#### **F.4     1250 Dallas Road: Development Variance Permit Application No. 00254**

**To:** Committee of the Whole **Date:** April 1, 2021  
**From:** Karen Hoese, Director, Sustainable Planning and Community Development  
**Subject:** Development Variance Permit No. 00254 for 1250 Dallas Road

1250 Dallas Road  
Development Variance Permit No.00254

project name:  
**Variance Application**  
1250 Dallas Road, Victoria, B.C.

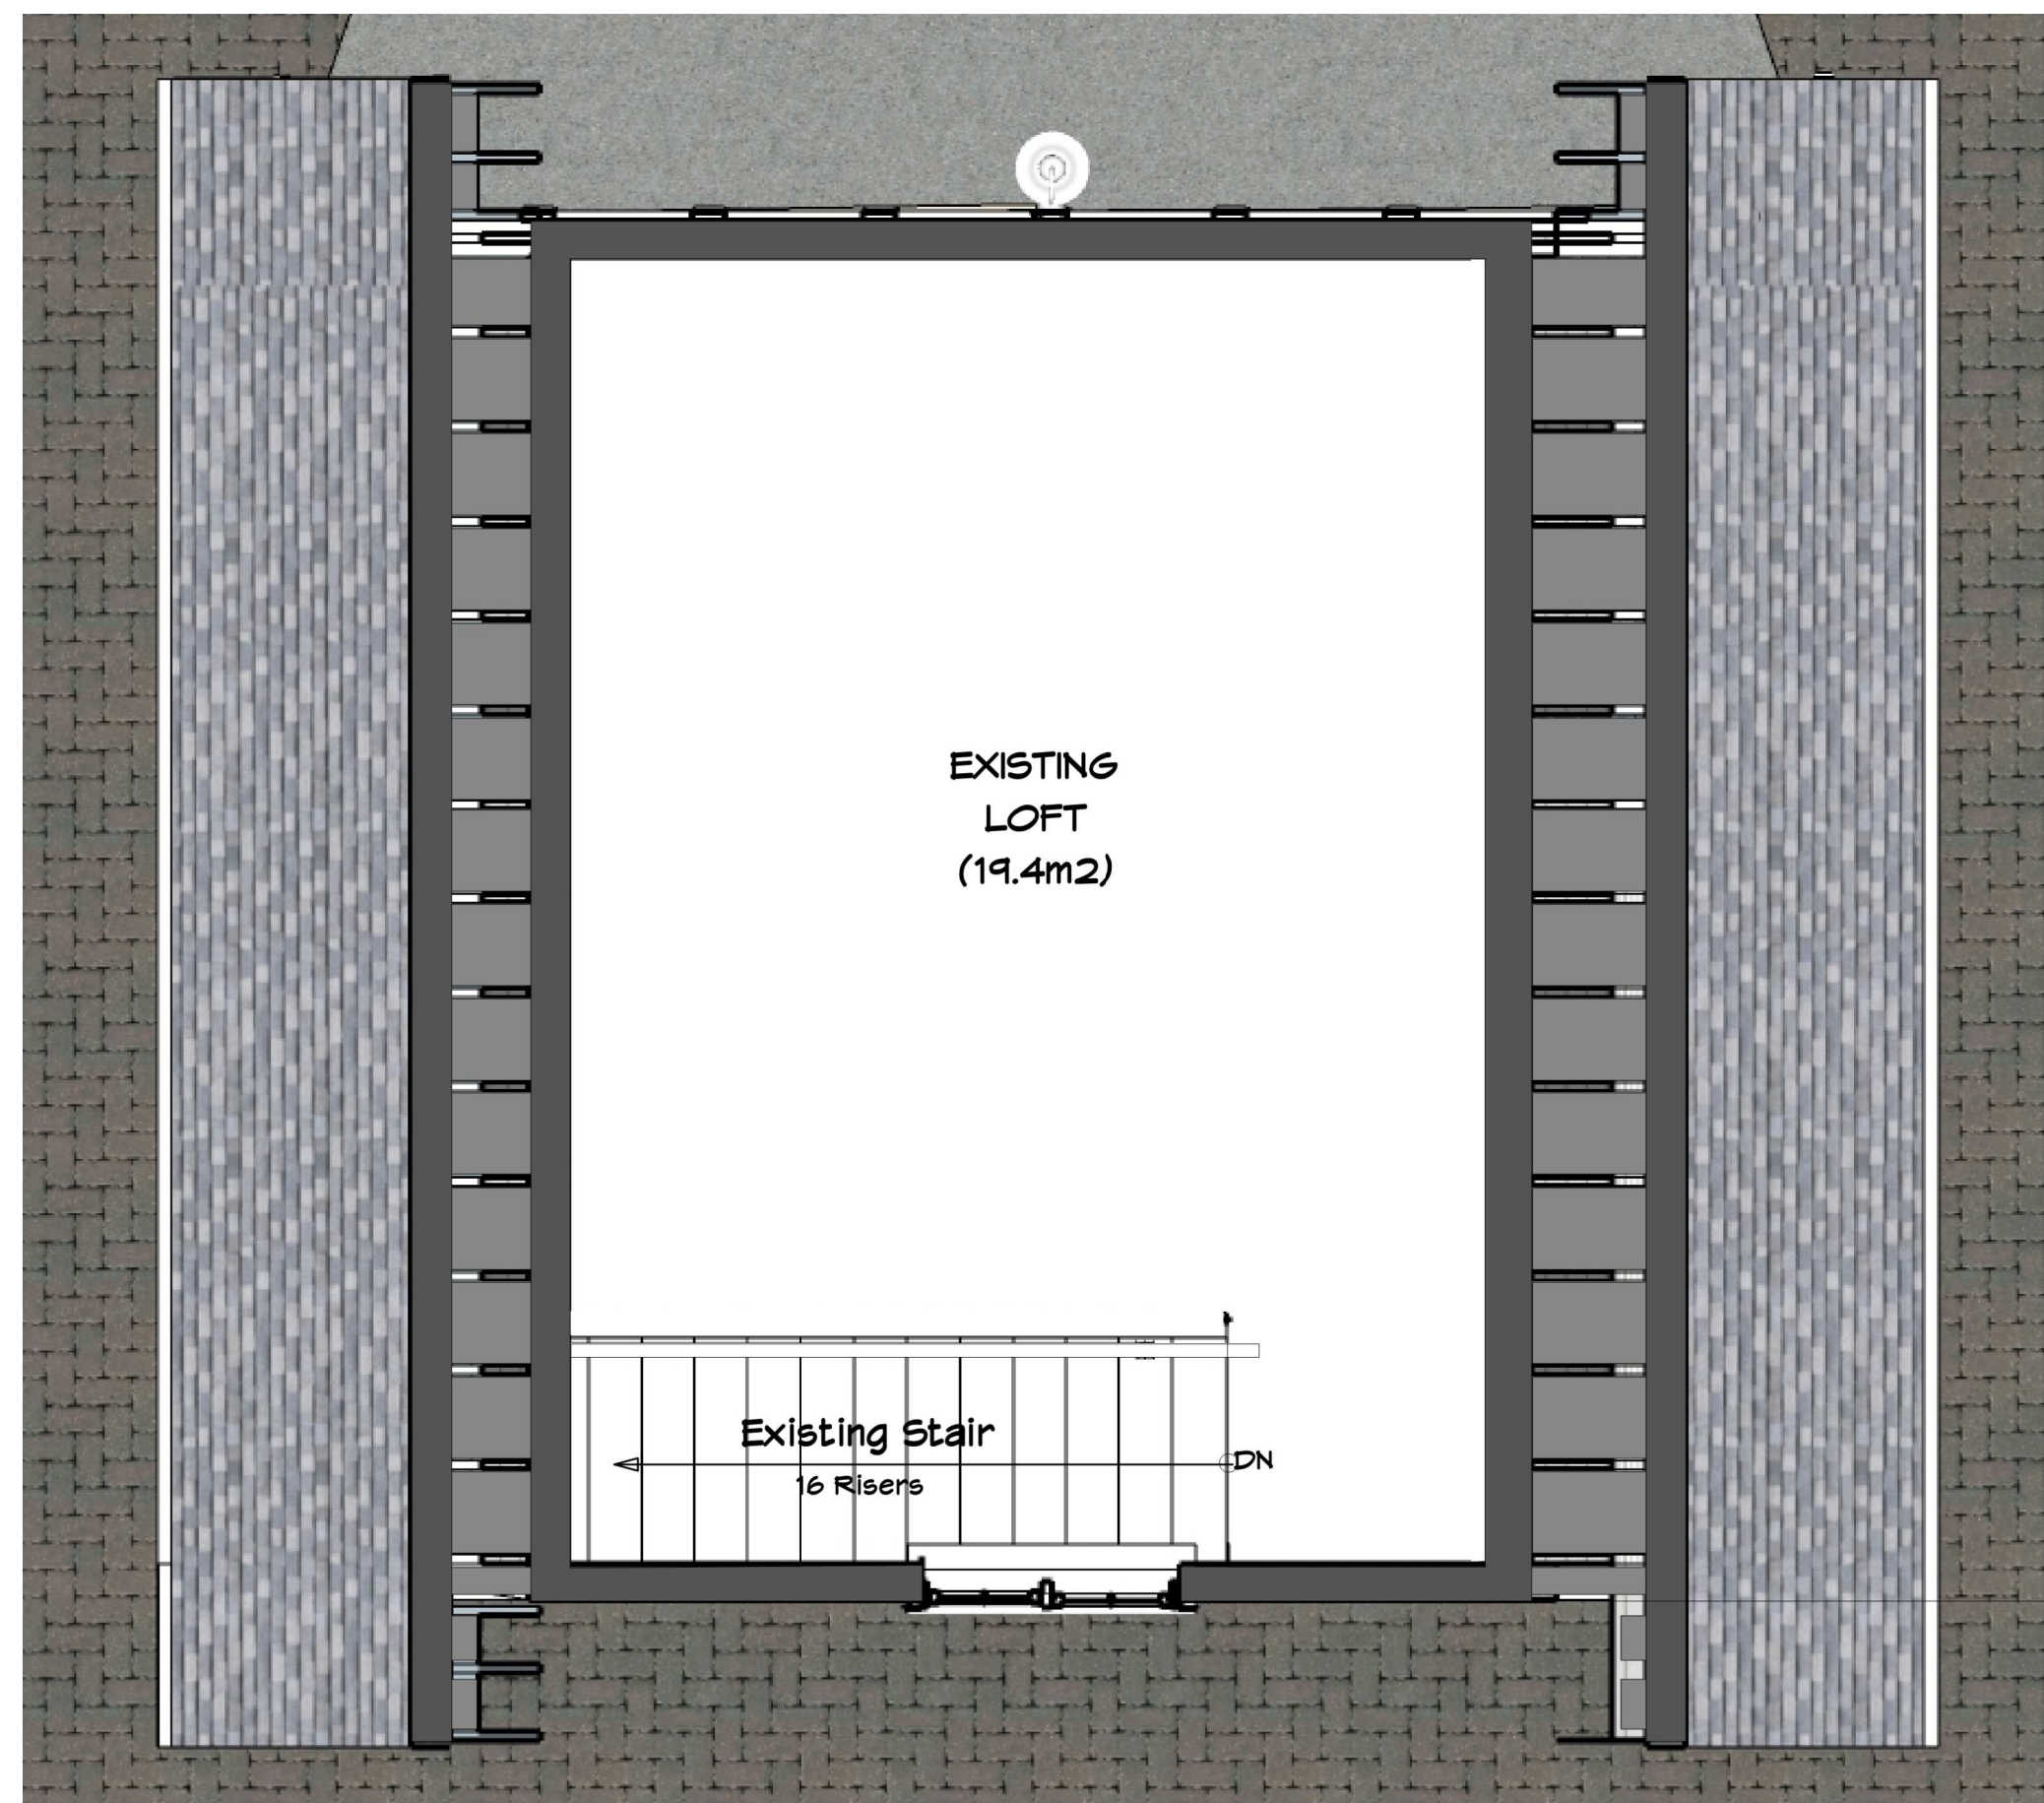
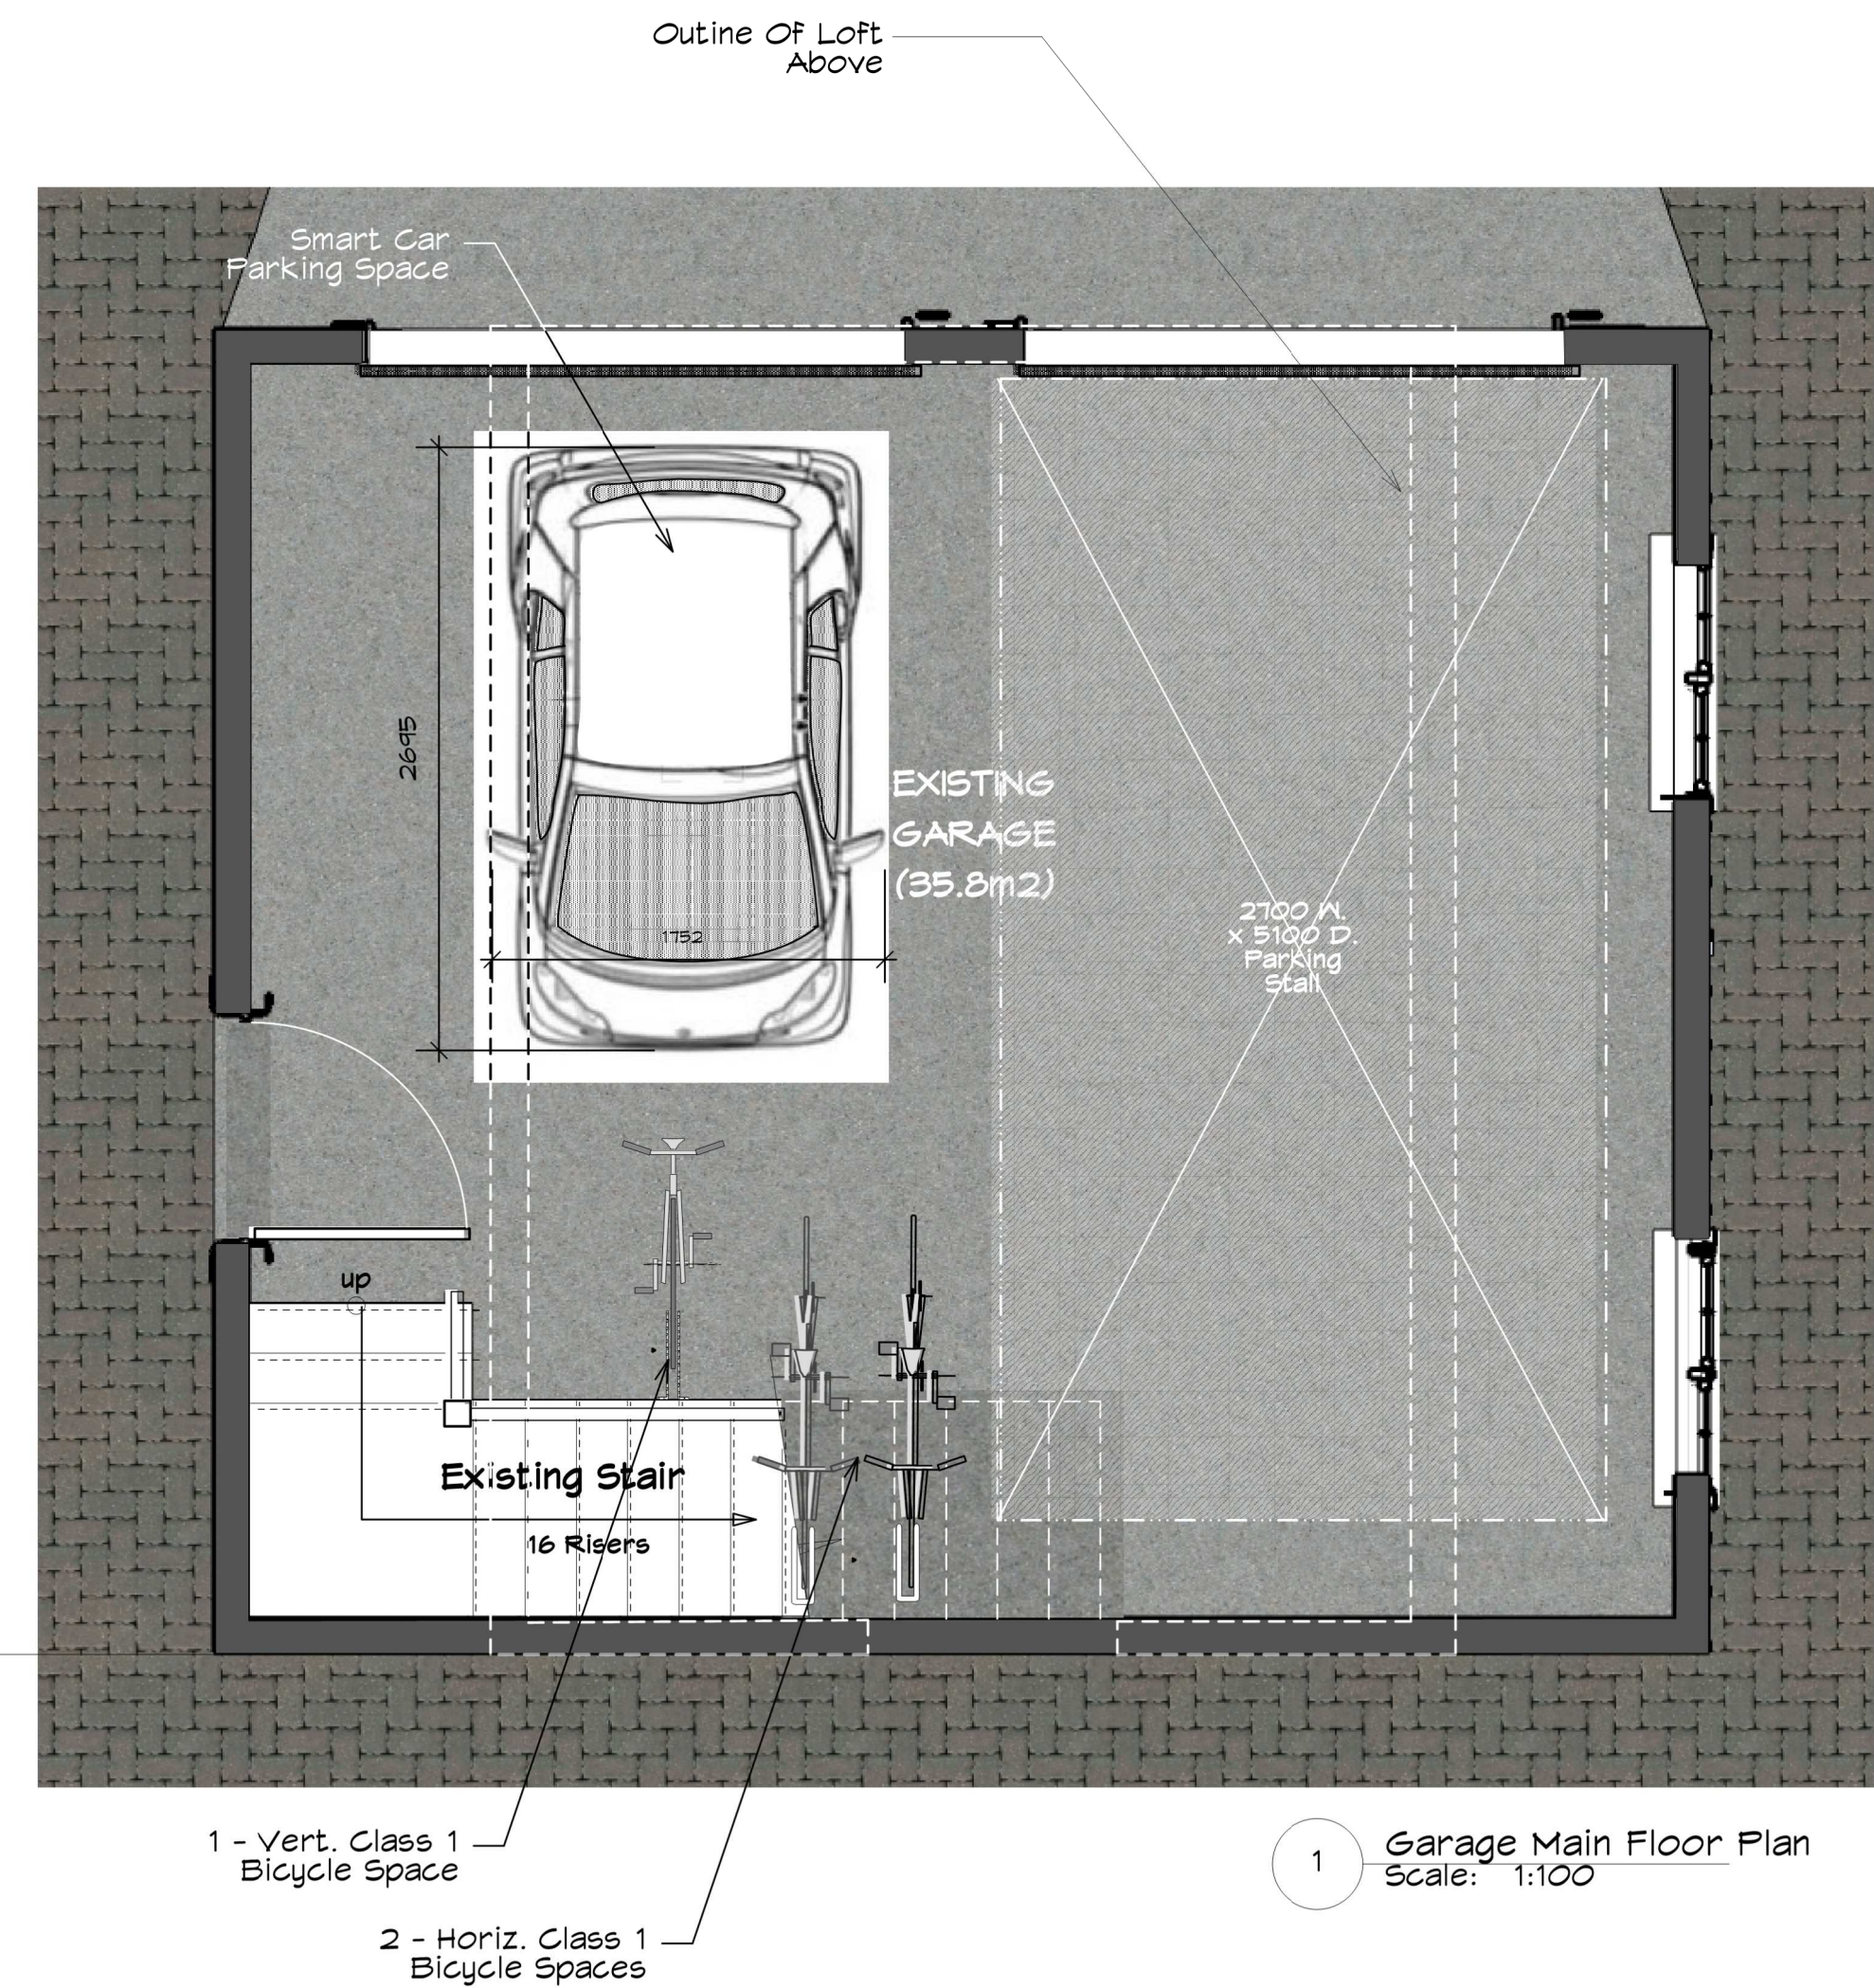
- The inclusion of dormers in the accessory building is requested to provide adequate floor to ceiling height so this area can be used as an amenity area by the residents. The dormers and the reconstruction of the roof require a height variance to increase the height of the accessory building from 3.5m to 4.73m.

- The loft space will have a floor area of 19.2 m<sup>2</sup>, which requires an increase to the allowable floor area of an accessory building from 37m<sup>2</sup> to 55.2 m<sup>2</sup>.

- Adding stairs within the garage, to access the loft space, reduces the size of one of the parking stalls, and, as such, the length of the stall does not meet bylaw standards of 5.1m reducing it to 2.695 m therefore triggering the requested variance.

With the addition of dormers in the roof to allow for usable height in the loft area, the height is now calculated differently (from the mid-point of the shed dormers) and the new height is deemed to be 4.73m. At the roof peak, the actual increase in overall height is approximately 0.26m to allow for the reconstruction of the roof. From the public realm, this additional height will not have a significant impact.

As previously noted, the accessory building was in place at the time of the 2017 rezoning. The existing floor area is 35.8m<sup>2</sup>. According to the project's architect, the loft area was in existence at the time of the rezoning, however, as it was not accessible it did not contribute to the floor area. By adding stairs to access the space and dormers to provide adequate ceiling height for use, an additional 19.4m<sup>2</sup> of floor area is added to the accessory building.
